DYNAMIC
Fire Protection Systems, Inc.

**Rio Vista Condo's
305 Society Drive
Telluride, CO 81435**

Inspection Date: 8/27/2012

Explanation of "NO" Answers:

FIGURE 7.6.3.3 Arrangement of Supply Piping with Back-flow Device.

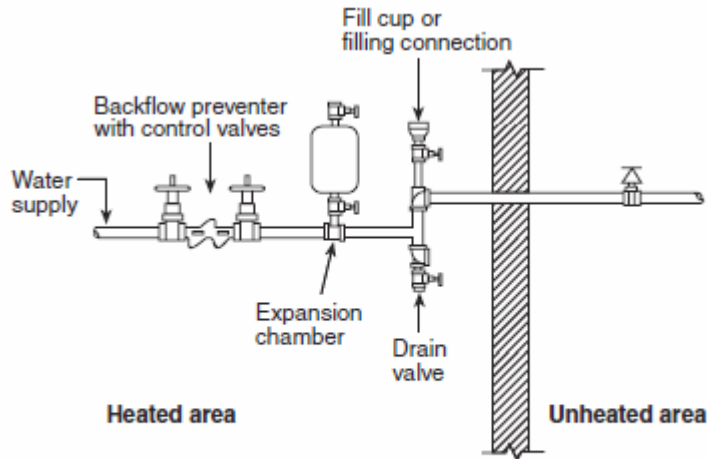
- 8. Install U. L. Listed Thermal Expansion Tank on the antifreeze system.
NFPA-13, 2010 – Section 7.6.3 “Arrangement of Supply Piping and Valves” and 7.6.3.3**

7.6.3.3* Where the connection between the antifreeze system and the wet pipe system incorporates a backflow prevention device, and the conditions of 7.6.3.5 are not met, a listed expansion chamber shall be provided to compensate for thermal expansion of the antifreeze solution as illustrated in Figure 7.6.3.3.
